I. AMENDMENTS TO THE DRAWINGS

Fig. 16

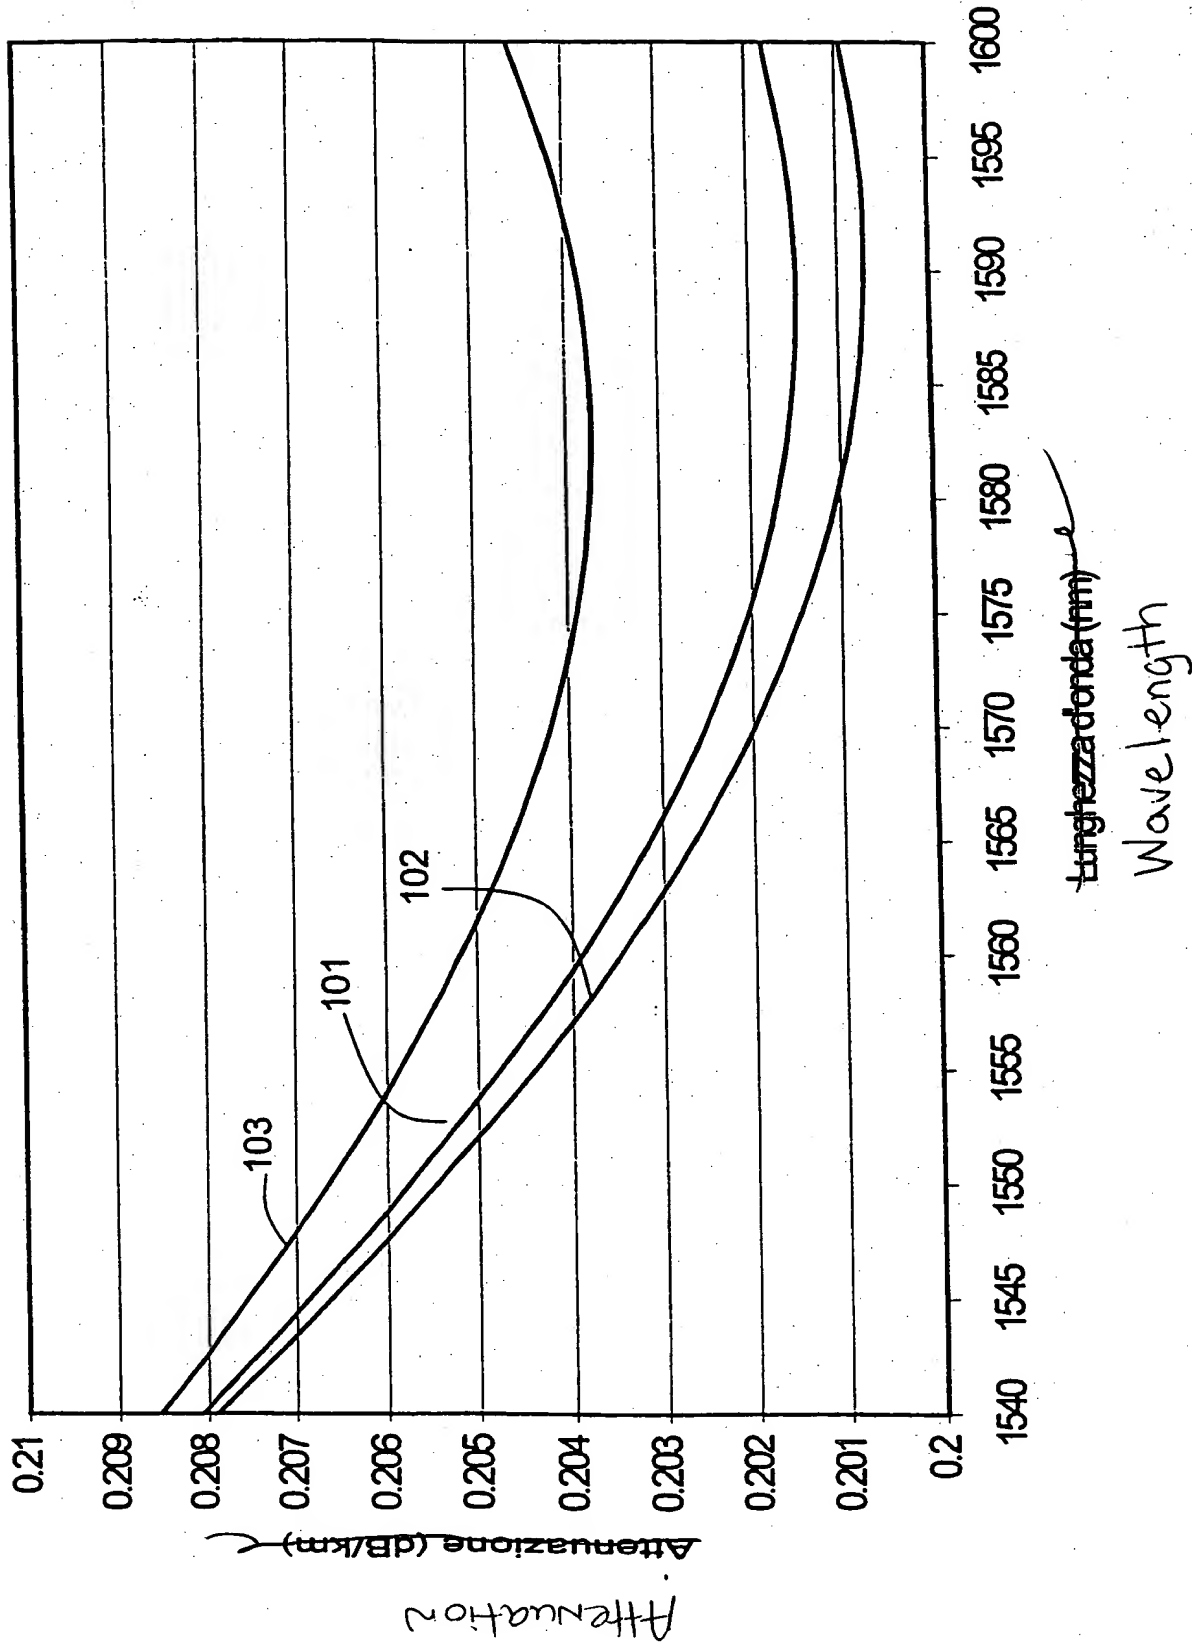
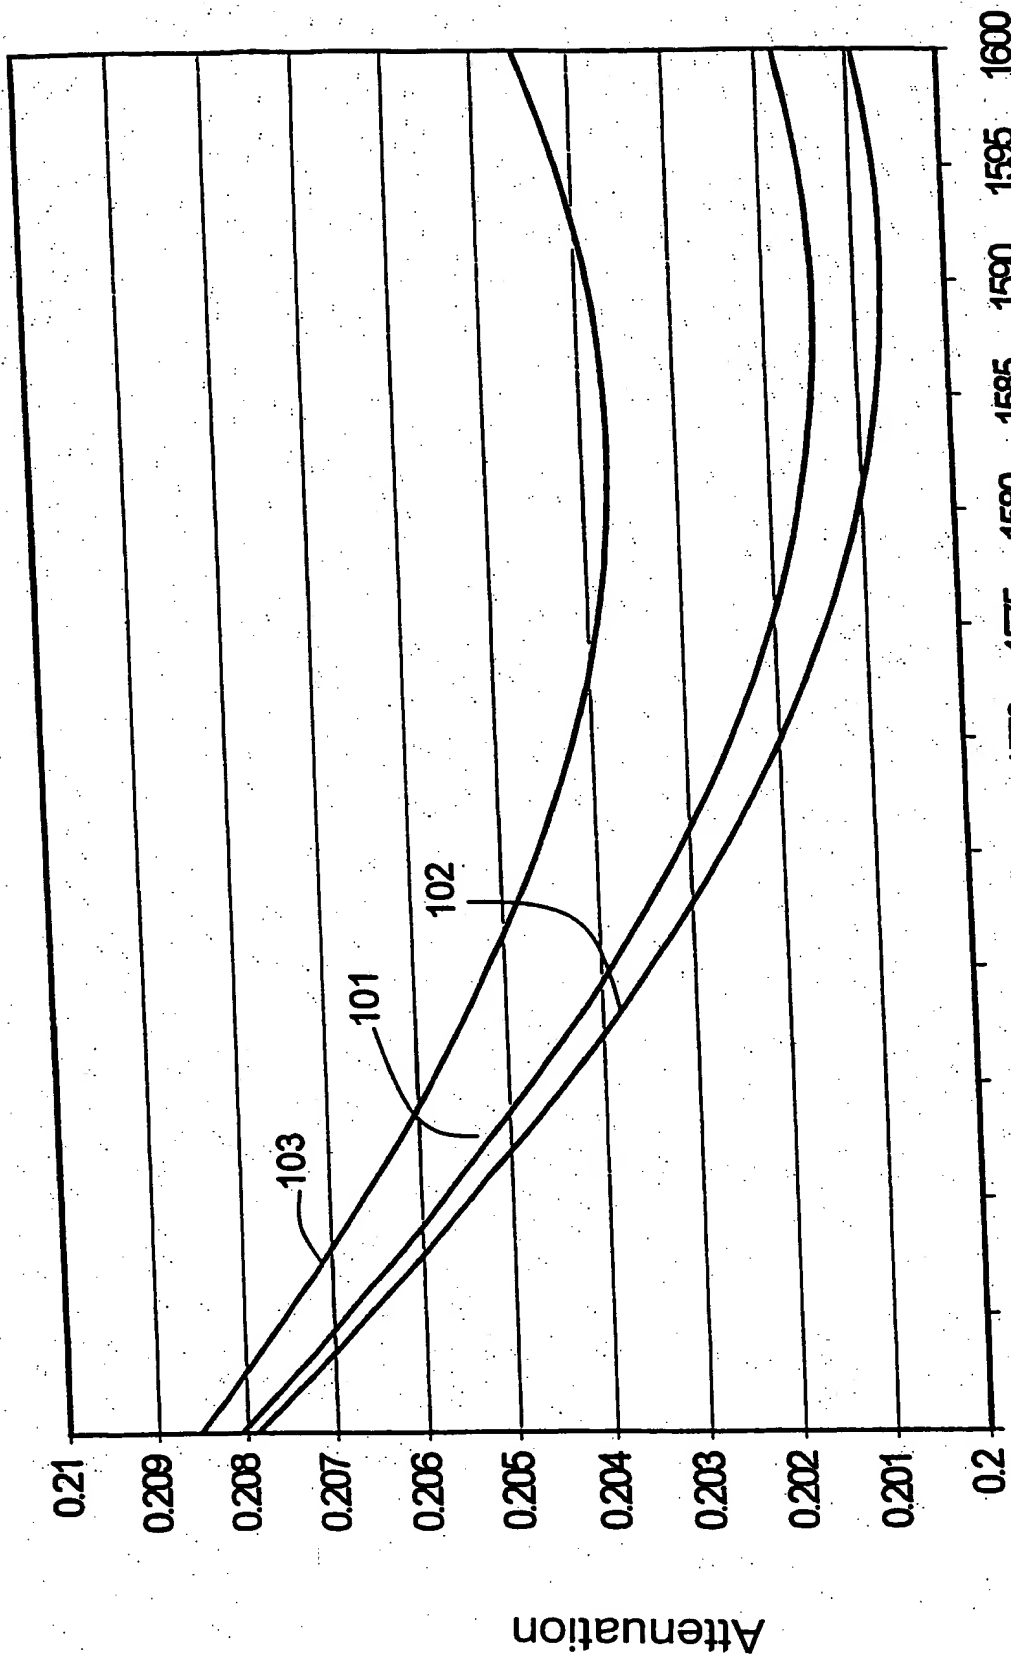
Figure 16 has been amended as shown on the follow Amended Sheet and Replacement Sheet of Fig. 16, by changing the horizontal axis label to "Wavelength" and changing the vertical axis label to "Attenuation."
